Form 3160-5 (August 2007)

| SUNDRY NOTICES AND I | REPORTS ON WELLES Land Manag |

| apandoned wen. | USE FUIII 3 160-3 (A | (PD) for such proposals. | | | | | |
|--|------------------------------|---|--|--|--|--|--|
| ☑ Oil Well ☐ Gas V | Vell | | 8. Well Name and No. Lybrook E27-2306 01H | | | | |

Other Footage Clarification

| | | W | ELL L | OCATIO | N AND A | ACREAGE | DEDIC | ATION PLA | T Fa | rmingto | on Field Office | |

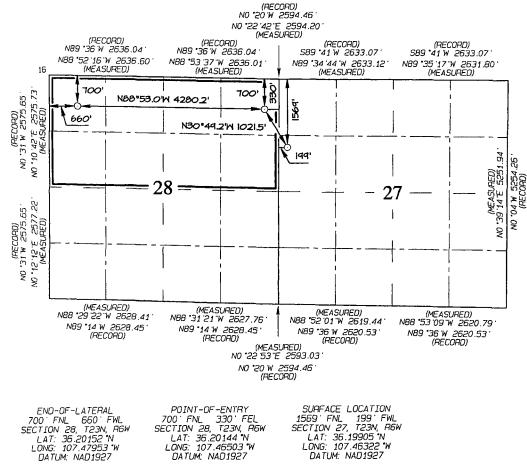
Encana Oil & Gas (USA) Inc. (Encana) wishes to submit re-clarification for the intended SHL, POE and BHL footages for the Lybrook E27-2306 01H well prior to the submittal of the Well Completions Sundry, which is dated March 11, 2014. The intended footages should have been as follows:

Surface Hole: 1569' FNL, 199' FWL Section 27, T23N R6W Point of Entry: 700' FNL, 330' FEL Section 28, T23N R6W Bottom Hole: 700' FNL, 660' FWL Section 28, T23N R6W

An executed C-102, dated March 1, 2014 reflecting the above footages is enclosed.
